Ōhoka Residential Subdivision Expert Panel Chair

Ōhoka FTAA – Geotechnical Review

Purpose of the document

Figure 1: Environment Canterbury aerial and satellite imagery observation of inferred liquefaction following 4 September 2010 (data source Canterbury Maps)

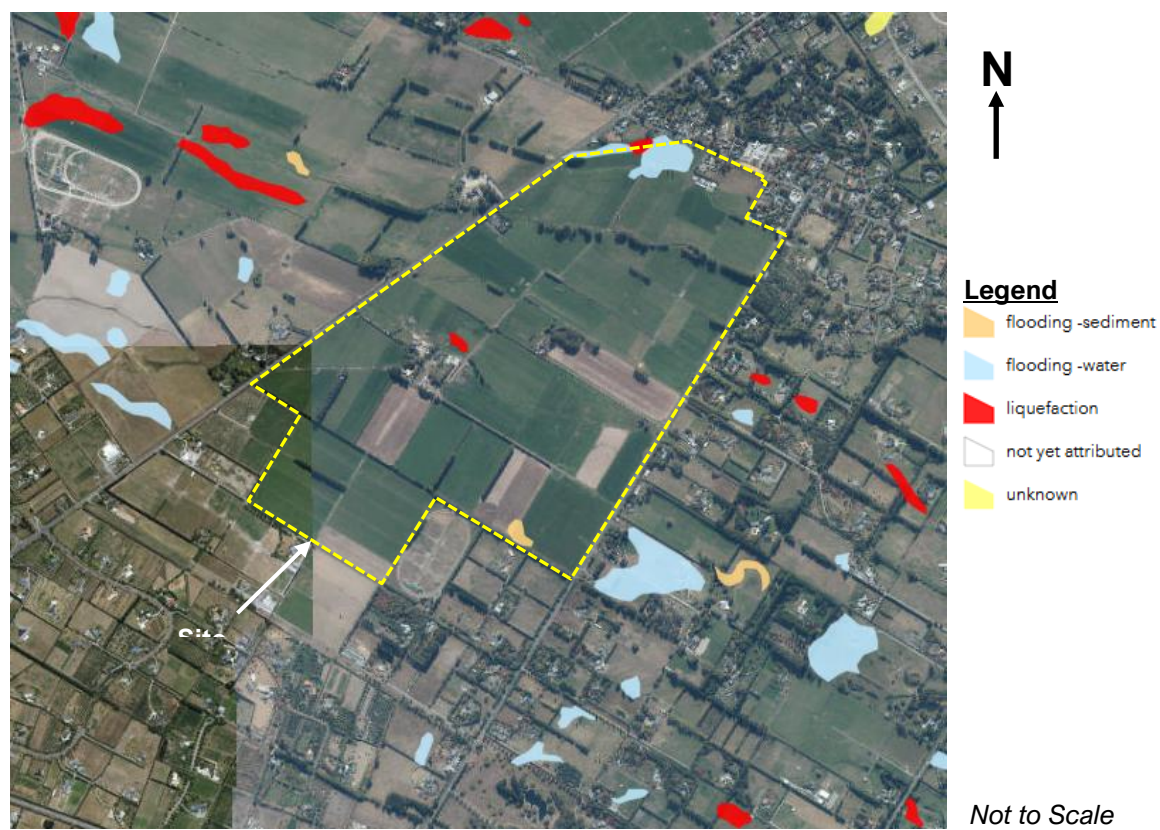
11. The 4 September 2010 Mw 7.1 earthquake generated an estimated peak ground acceleration (PGA) of approximately 0.17g at the site (source Canterbury Geotechnical Database), resulting in two areas of observed liquefaction ejecta and surface flooding along the northern boundary of the site (refer Figure 1). The 22 February 2011 Mw 6.2 earthquake generated a peak ground acceleration (PGA) of approximately 0.13g at the site (source Canterbury Geotechnical Database). This resulted in minor localised flooding with sediment immediately south and northeast of the site, although no direct effects were recorded within the site itself (refer Figure 2). The occurrence of liquefaction and flooding, together with the relatively shallow groundwater levels and potential presence of liquefiable soil lenses, indicates that a residual liquefaction hazard exists at the site. I disagree with Tetra Tech Coffey's conclusion that liquefaction risk is "negligible". In my opinion, this conclusion is inconsistent with the observed site performance during the 2010-2011 Canterbury earthquakes and is not supported by a quantitative liquefaction assessment in the geotechnical report.
